Product code: CS13t-60

Description: Jaguar XJR6/9/12 chassis AW compatible EVO6

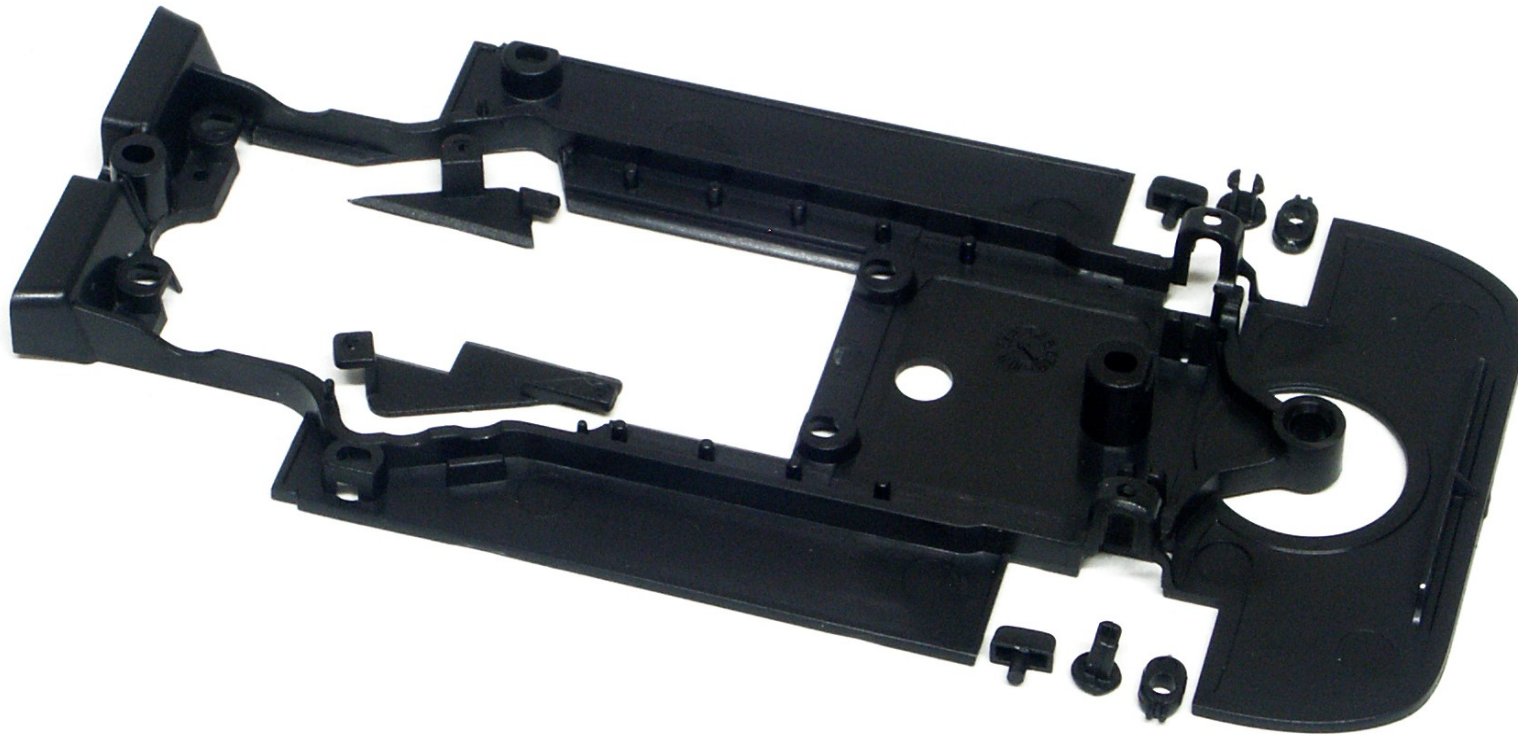
- compatible with EVO6 anglewinder motor mount
- shrunk central part for a better play (body to chassis)
- the plastic bushings of front axle may be substituted with either:
 - 3 mm grub screws to regulate axle play
 - brass bushings code CH56 to reduce friction when front wheels touch ground
